FIVE MINUTE SETTLEMENT – METERING PROCEDURE CHANGES - (PACKAGE 1)

SECOND STAGE PARTICIPANT RESPONSE TEMPLATE

Participant: AGL

Submission Date: 15 Feb 2019

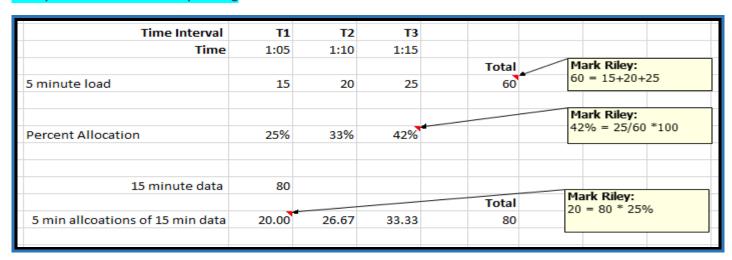
Section	Description	Participant Comments
2.3	Jurisdictional Update	Noted
2.4	Change to 'F' Metering Data Quality Flag	Noted – however:
		Inconsistency in cross references -
		Table Quality Flag F
		Is the reference to 2.5(e) correct as this refers to a RoLR event or should it be (f).
		Should 2.5(h) also be included in this statement to be consistent with the statement at the end of the clause.
		Final Statement
		Cross Reference error - the final statement for "F" metering data refers to clause 2.5.1 in three instances.
		There is no clause 2.5.1 – only 2.5
		The table and statement are dealing with the concepts of updating F quality data and replacing F data with A data.
		AGL suggests that the two areas be reviewed and re-written to make it the various obligations and exceptions clearer.
2.6	Page number links replaced with section links	Agree
